Model 200 D/8, 220 D/8, 200/8 and 220/8

Fig. 01-7/1

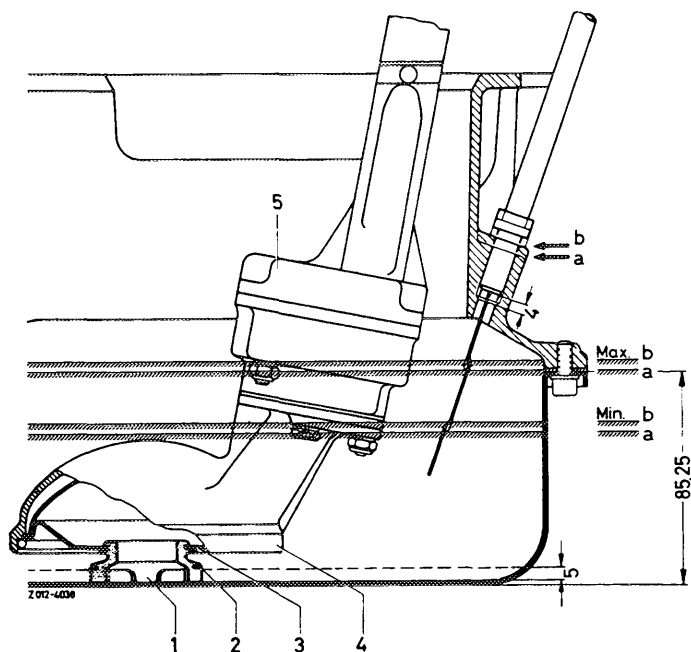
The oil pan of the 4-cylinder engines has been made larger and the oil capacity is now increased by 0.5 liter.

On oil pans with increased capacity the base is drawn 5 mm deeper and the guide tube for the dipstick on the oil pan to has been set higher (refer to item a and b in Fig. 01-7/1).

Engines with oil pan bottom drawn deeper are provided with a compensating piece (1) on oil pump strainer.

In the event of repairs be sure that the compensating piece is installed only together with the new and deeper oil pan base.

When converting from the former oil pan to the new one having a larger filling capacity, also replace screen (3) in strainer of oil pump for new version so that the compensating piece can be attached.

Even when only the deeper oil pan base is installed, the filling capacity must be increased by 0.5 liters. The oil level when full will then actually be slightly above the max. mark on dipstick.

On earlier vehicles the filling capacity should not be increased when the former oil pan is retained.
